Access Compliance Report

Public Rights-of-Way

(Pedestrian Signals)

Intersection ID: N/A	Main Street:	Cross Street: N/A	Location: N/A
ADA ID: 06CEE789F4B2	Signal Type: One Push Button-Non APS	Overall Compliance: No	Severity Score: BTN 1: N/A BTN 2: N/A No BTN: N/A
Codes/Mitigation Info/Possible Solution		Field Measurements/Component Compliance

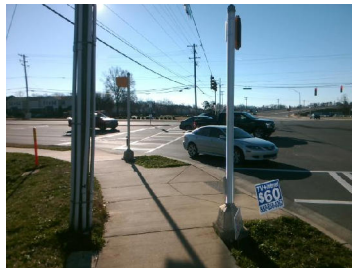
PROW/ADA: TMUTCD 4e.08, R406.2

Possible Solutions: Replace Signal Push Button With APS Button on New Post. Remove & Relocate Sign.
